Product Change Notification / KSRA-24HJEE206

CCB 4254 Final Notice: Qualification of GTK as a new assembly site for selected Atmel products available in 24L SPDIP (.300in) package.

CCB 4254
Pre and Post Change Summary
PCN#: KSRA-24HJEE206

Pre change (LPI)

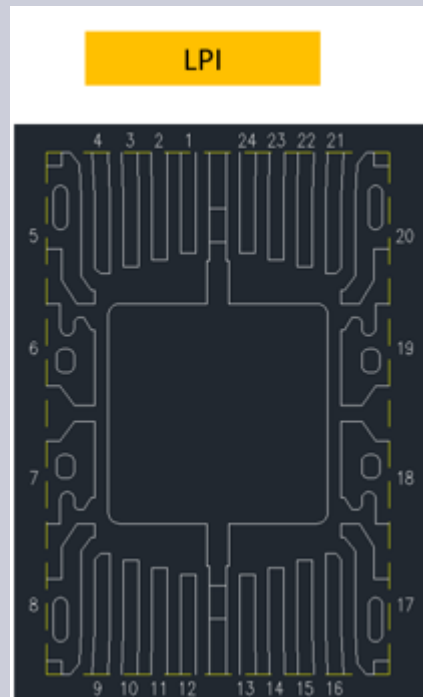
Lead frame DAP surface prep

Double ring plating

Post Change (GTK)

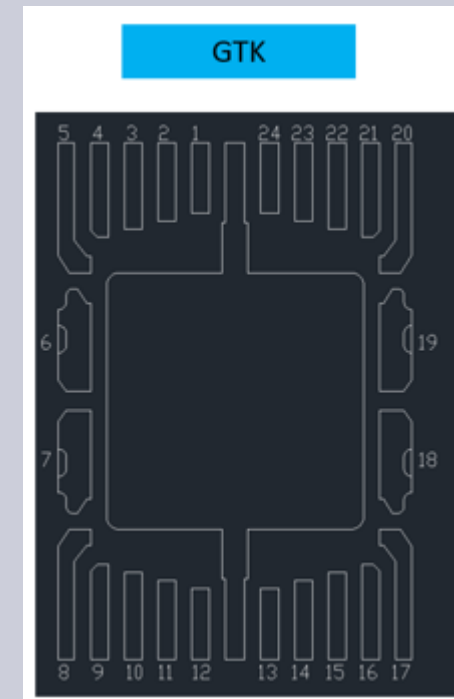
Lead frame DAP surface prep

Spot plating
